UNITED STATES PATENT AND TRADEMARK OFFICE

APPLICATION NO.	FILING DATE	FIRST NAMED INVENTOR	ATTORNEY DOCKET NO.	CONFIRMATION NO.
10/067,358	02/07/2002	Hajime Yamamoto	03500.016161	7437
	7590 05/21/2004		EXAMINER NGUYEN, JUDY	
FITZPATRIO 30 ROCKEFE	CK CELLA HARPER & LLER PLAZA	SCINTO		
NEW YORK,			ART UNIT	PAPER NUMBER
	• • •	, ·	2861	
	*	*	DATE MAILED: 05/21/2004

DETAILED ACTION

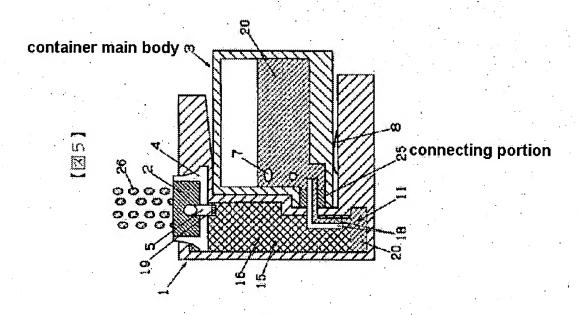
Miyazaki et al discloses all features of the claimed ink container as follows:

- A container main body [8] for containing ink;
- A connecting portion [12+13] to which the ink deriving tube [41] and the air introducing tube [42] are connected;

- Said connecting portion [12+13] being provided at a bottom surface of said container main body [8];
- A portion [the portion where 12+13 is located] of said ink container deviated to
 either one of side walls with respect to a center portion of said bottom surface of
 said container main body [clearly illustrated in Figs. 7A-7D];

- An identification information structure [see 10a, 10b, 10c, 10d of Figs. 6A-6C] at a part of said side surface of a shorter side of said ink container;

- Said ink container has an external shape of a flat thin type of rectangular solid [see Figures 6, 7];
- Said connecting portion [12+13] comprising multiple connection elements including an ink deriving connection element [13] and an air introducing connection element [12], wherein each connection element [12, 13] is independently provided at a portion deviated from a center portion of said container main body bottom surface to either one of the side surfaces of the shorter side [clearly illustrated in Fig. 7C], and wherein said ink deriving

connection element [13] is placed at a position closer to a side surface of the short side and said air introducing connection element [12] is placed at a position closer to a center than said ink deriving connection element [13];

- Said air introducing connection element [12] is provided with a tubular member near the bottom surface, the tubular member being oriented inward of said container main body and projecting slightly [see Fig. 7A];

- A bottom surface [see Fig. 6C] of said ink deriving connection element [13] is disposed at a position lower than said bottom surface of said ink container main body [8];

- An elastic member [paragraph [0045] disclosed rubber plugs which is read as
 elastic member] is disposed at said ink deriving connection element [13] and said
 air introducing connection element [12];
